Our Ref: S6R/017e
Date: 30 July 2013

RE: Hydraulic Connection between Quaternary Alluvium and Tertiary Palaeochannel in the Moolarben Groundwater Model

We have prepared this letter in response to correspondence from the NSW Office of Water (NOW – Reference No. ER20274, dated 1 July 2013) to provide clarification on the hydraulic connection between the Tertiary palaeochannel deposits, the Quaternary alluvium and modern-day drainage system in the numerical groundwater model for the Moolarben Coal Project.

Figure 1 – Model Layer 1 – Hydraulic Property Zones (Mine Year 0) – Scenario 1
Figure 2 – Model Layer 1 – Hydraulic Property Zones (Mine Year 0) – Scenario 2

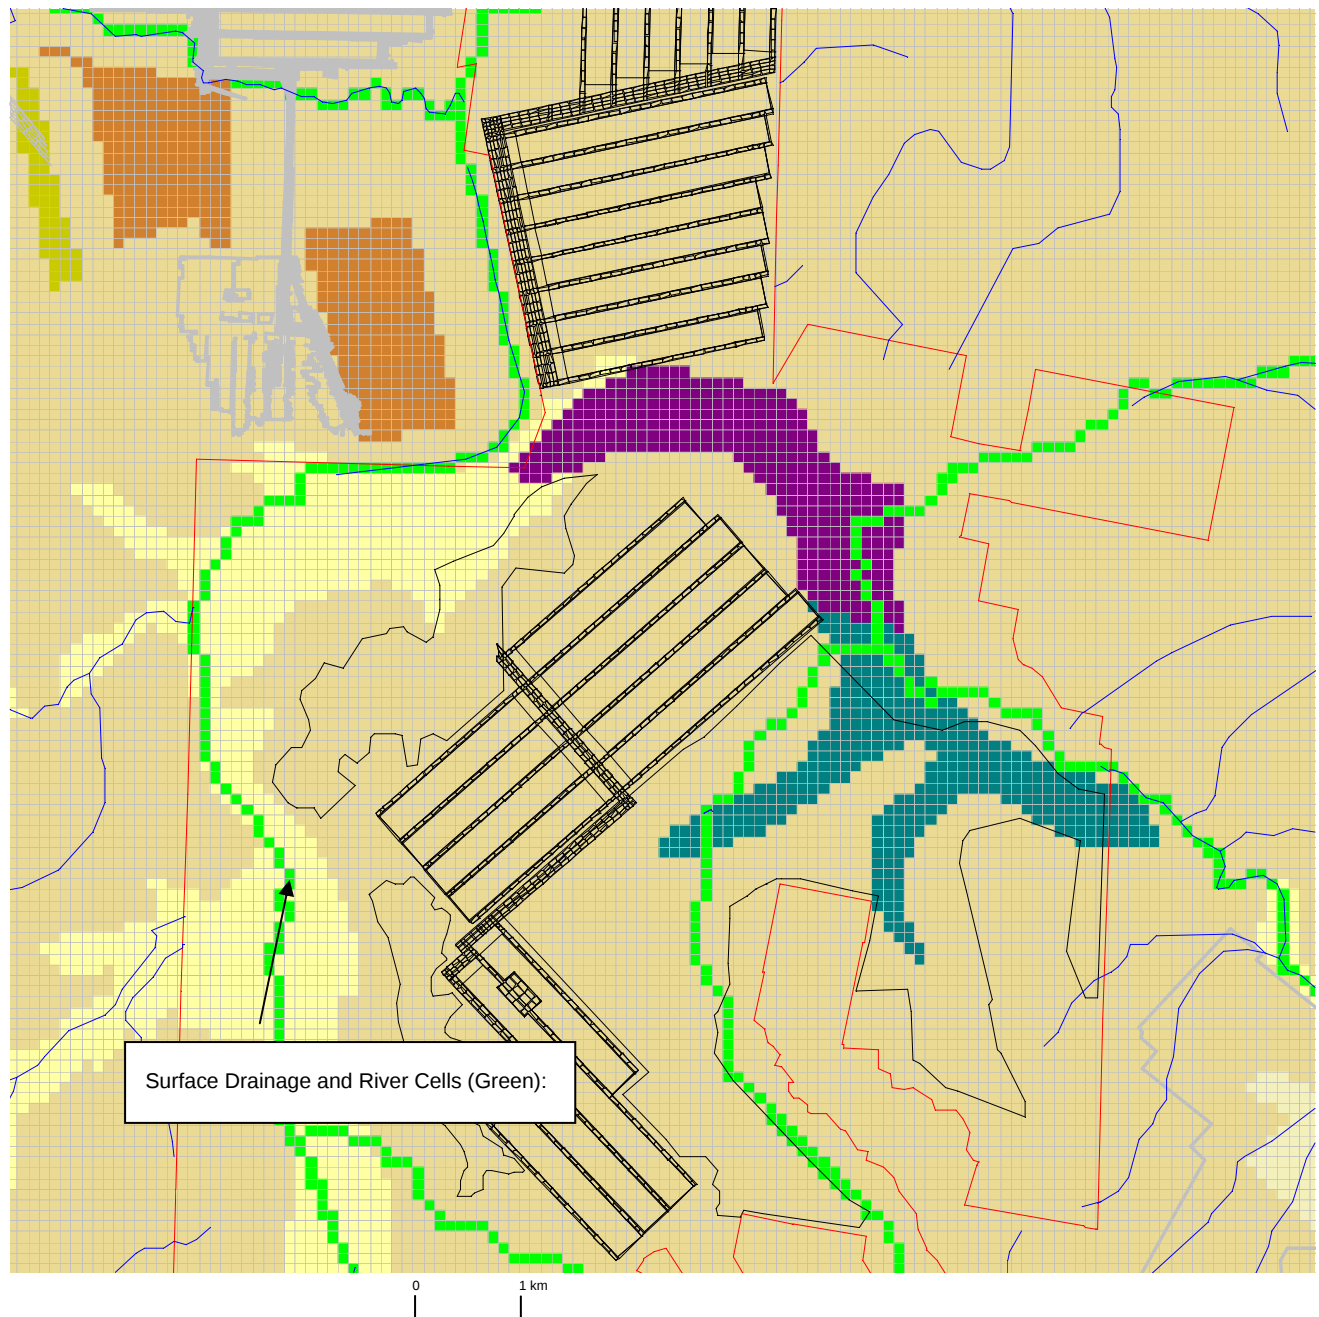
As identified in Dundon (2013), hydrogeological field investigations imply that the Tertiary palaeochannel may not be hydraulically connected to the modern-day drainage system. However, in the numerical model, these units are constructed to be directly hydraulically connected (by virtue of the assigned parameters). This has been the case in each of the 2011 and 2012 versions¹ of the model (RPS, 2011 and 2012) and the recently completed sensitivity modelling (Dundon, 2013). That is, all Layer 1 is internally hydraulically connected in addition to being hydraulically connected to the modern-day drainage system, where they overlap. Further, where the palaeochannel has been identified to occur, all material in these areas (from the surface to the base of the palaeochannel) has been assigned the same hydraulic conductivity value.

- Figure 1 shows the distribution of Layer 1 zones of hydraulic properties for the Scenario 1 sensitivity model run.
- Figure 2 shows the distribution of Layer 1 zones of hydraulic properties for the Scenario 2 model run.

It can be seen from the figures that the complete section of unconsolidated material within the extents of the identified palaeochannel have been assigned the *same* (higher) hydraulic conductivity value regardless of whether Quaternary alluvium exists in this area or not. That is, there is no separate representation in the model of Quaternary alluvium in areas where it exists within the extent of the palaeochannel alluvium. (Note however, as reported in Dundon (2013), the published 1:100,000 geological map of the area shows *no* Quaternary alluvium in the vicinity of the Stage 2 open cut mine).

These figures show Zone 3 (pale yellow – representing Quaternary alluvium) is directly connected to Zone 9 (purple – representing the interpreted Tertiary palaeochannel trunk), which is connected to Zone 10 (cyan – representing Murrumbidgee and Eastern Creek tributaries). Each of these zones is connected to surrounding regolith, Quaternary alluvium (where it exists) and the overlying surface drainage (where applicable). The figures show a plan view of the model with the $100\text{m} \times 100\text{m}$ model grid cells clearly visible. (Note the presented figures show the pre-Moolarben mine case).
